**CANYON FUEL COMPANY, LLC
DUGOUT CANYON MINE**

C/007/039

PERMIT AREA EXPANSION

Deficiency List Task ID #2873 Permit Expansion Area – 240 Acres

Figure 2 Probable recharge area for springs 260 and 260A.

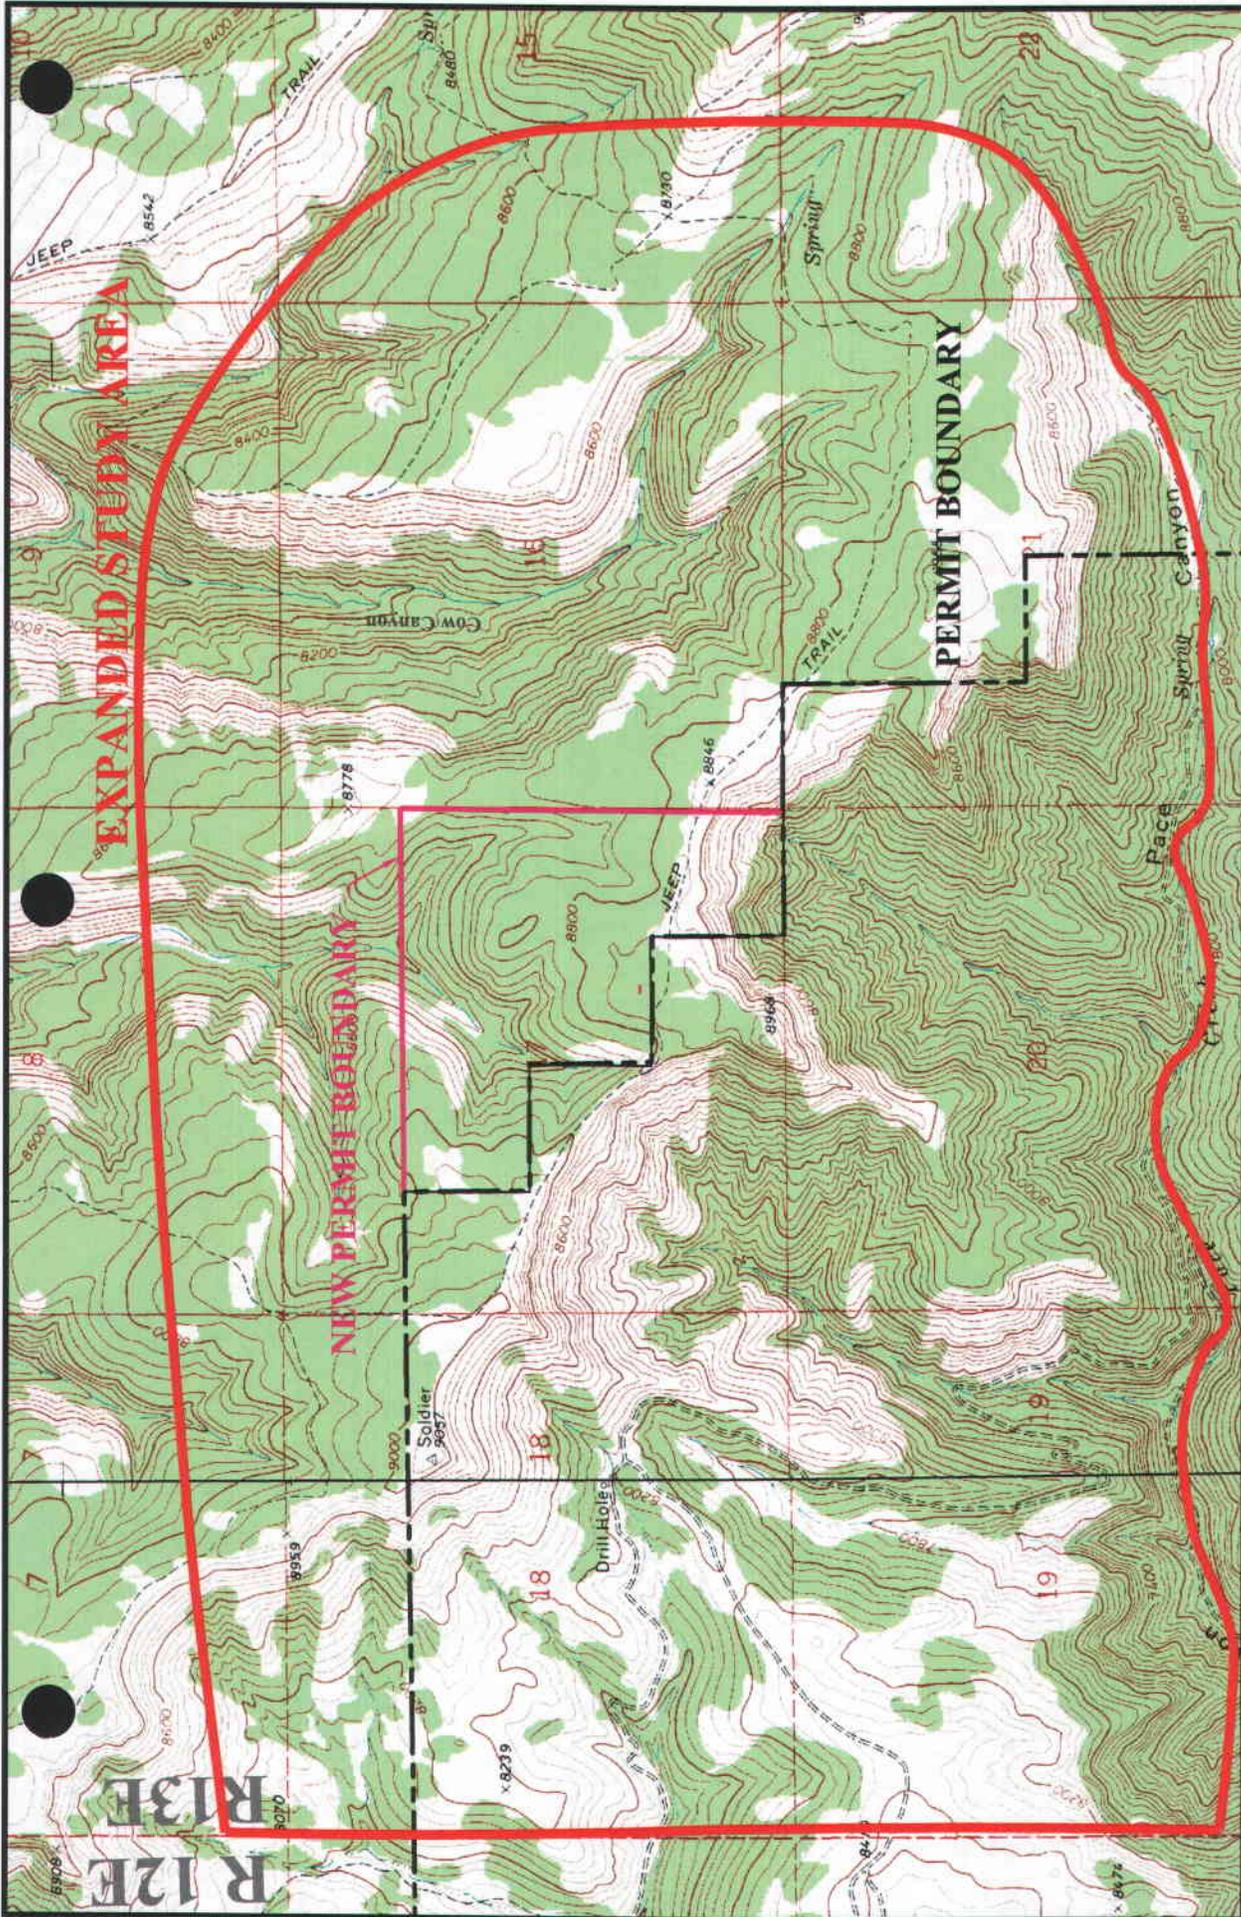
The application does not meet the Maps, Plans and Cross Sections requirements for Subsurface Water Resource Maps as required by R645-301-722.100. Page 7-2 of the application provides a reference to Figure 7-1 of the approved MRP. Figure 7-1, General Hydrostratigraphic Cross Section, is labeled as "Modified from Lines (1985)". Upon review, the Lines, 1985 technical paper is entitled "The Ground-Water System and Possible Effects of Underground Coal Mining in the Trail Mountain Area, Central Utah", USGS Water Supply Paper 2259. Trail Mountain is located in the Wasatch Plateau. The Permittee offers no discussion as to how the generalized hydrogeology of the Wasatch Plateau is comparable to the Book Cliffs region where the Dugout facility is located. As required by R645-301-722.100, the Permittee should provide the appropriate cross-sections and maps that depict the "location and extent of subsurface water, if encountered, within the proposed permit or adjacent areas". As required, the cross-sections and contour maps should also include "seasonal differences of head in the different aquifers". (SC)

See Appendix 7-3, Addendum, Attachment 1, Figure 2. Also see Section 724.100, Groundwater Systems – Perched Groundwater System.

PHC FIGURE 1

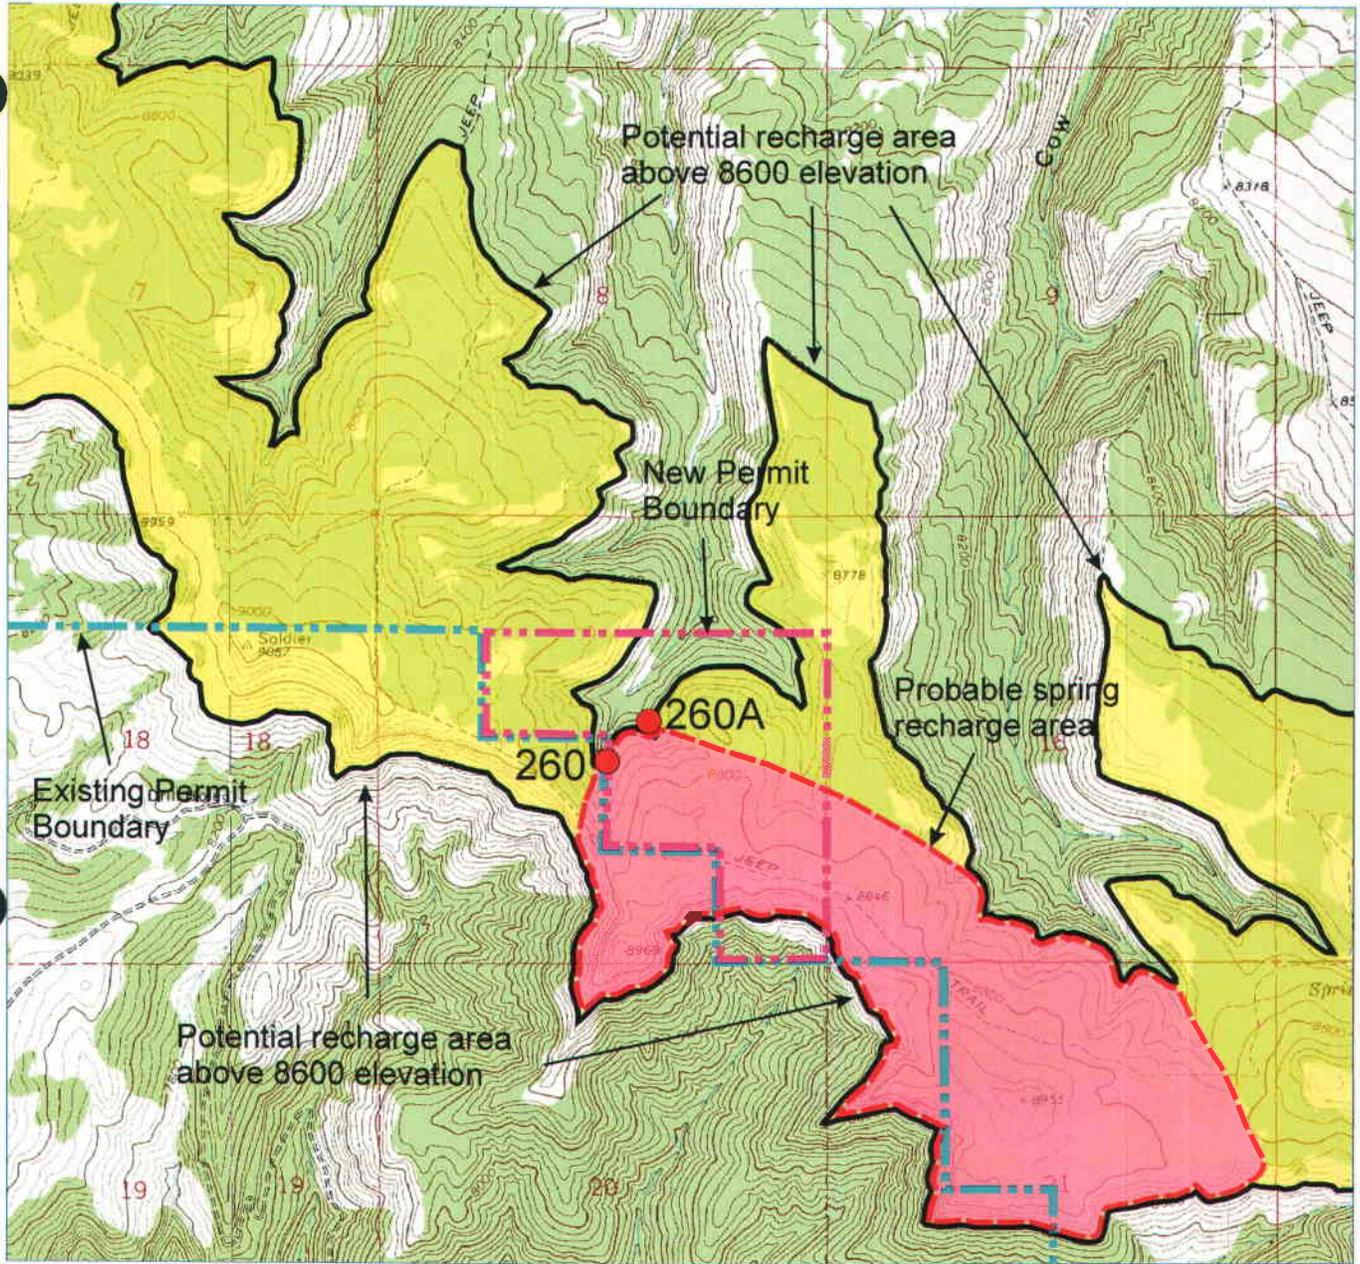
Section 2.3 of the Update To the Probable Hydrologic Consequences of Coal Mining at the Dugout Mine in Appendix 7-3, the Permittee states, "The 600 acre expansion sample locations are identified on PHC Update Figure 1". The submitted Figure 1 does not depict any sampling locations. The Permittee must address this discrepancy.
